Pittwater Data Services Pty Ltd
ABN 36098815537
27 Ashby Street
Dudley, 2290
Mobile: 0422 088 032
Email: pittwaterdataservices@live.com.au
Our Reference: PDS07112020:43PITTW:MANLY

Re: Flood Management Report Addendum for 43 Pittwater Road, Manly

SECTION 4.55 APPLICATION
43 PITTSWATER ROAD, MANLY
ALTERATIONS AND ADDITIONS
SOUTH ELEVATION AND SECTION

FIGURE 3

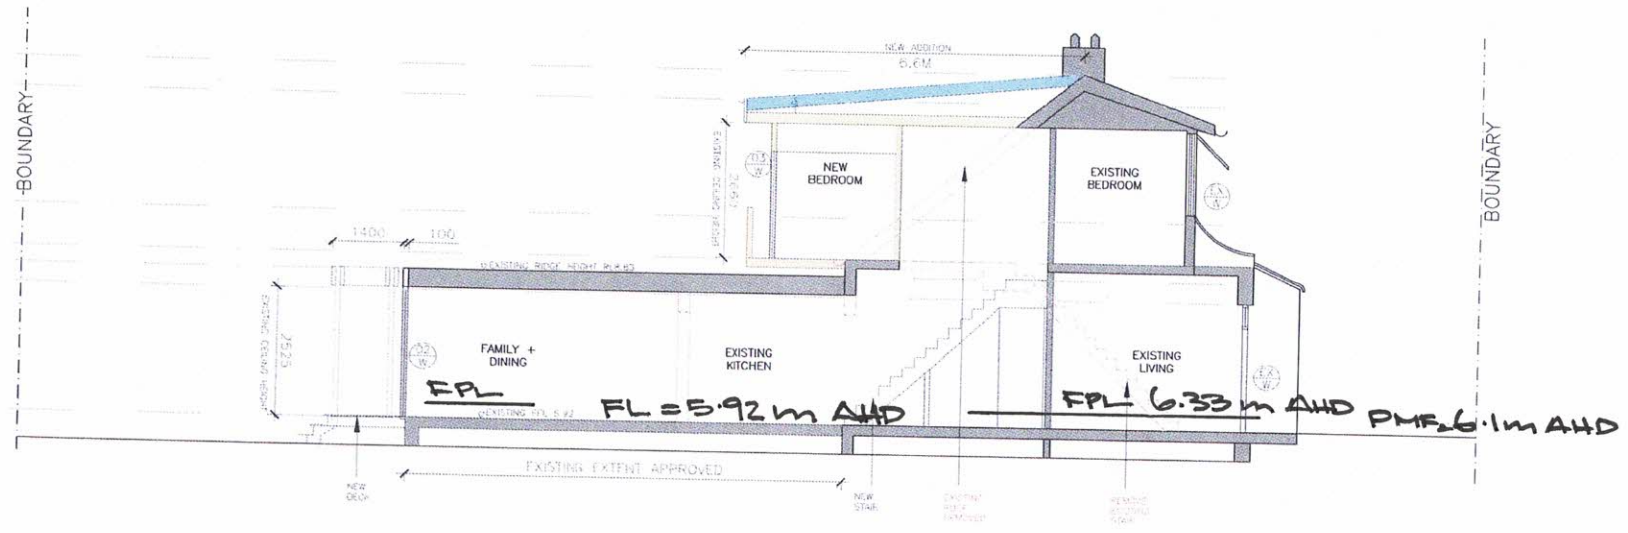
1. The retention of the original approval (3.2m2) with a designated use of a Family/ Dining room
2. Widening the southern wall of the Family/ Dinning room (4.4m2)
3. Constructing a deck on the western side of the Dwelling (5.1m2)
4. Additional bedroom on First Floor Level (Figure 3).

- All extensions are suspended floors on peirs.
- Habitable combined extensions area 7.6 m2. This includes 3.2m2 of the original approval (DA 2019/1126).
- Non habitable decking 5.1m2.
- First Floor Level above PMF (Figure 3).

F4. This requirement allows for up to 30 m² extension of an existing room below the Flood Planning Level (FPL). The proposal is an extension of an existing room by 7.6m² (including approved 3.2m²)

A3 No net loss of flood storage: there is approximately 0.032m³ of loss of flood storage from the piers. This is imperceptible considering the overall flood storage of the *site* and the accuracy of the 1%AEP flood predictions and therefore flood depths on the *site*.

In conclusion, considering the flooding processes at the *site* the design of the additions to the Dwelling as detailed in Figures 2 and 3, it is my opinion the revised design and the Flood Action Plan as detailed in the original Flood Management Report, will satisfy NBC Manly DCP Section 5.4.3 requirements.
